# Rezoning Transportation Analysis

Petition Number: #2022-123

Date	Description
12-28-22	First Review (TM)

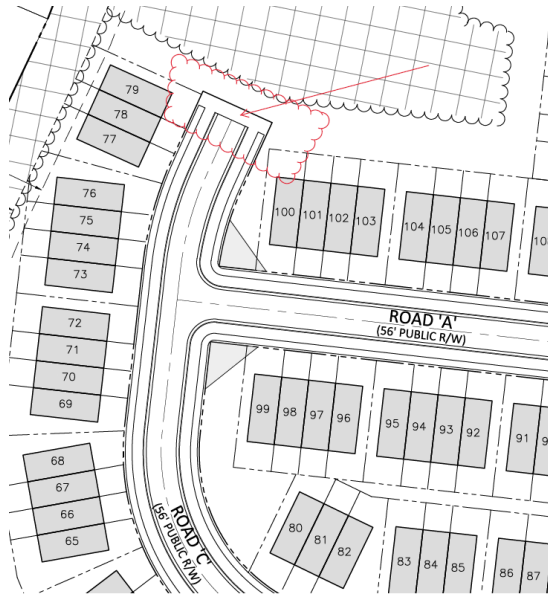
- a. **Gibbon Road:** Location of curb and gutter to be moved to 19 feet from roadway centerline to accommodate the Charlotte Streets Map with a roadway typical section of CLDSM 11.09 Minor Thoroughfare.

NOTE: Additional distance from center line to back of curb may be required in locations where a median is present or around intersections and interchanges.

Label and dimension the curb and gutter from the centerline for each road on the site plan.
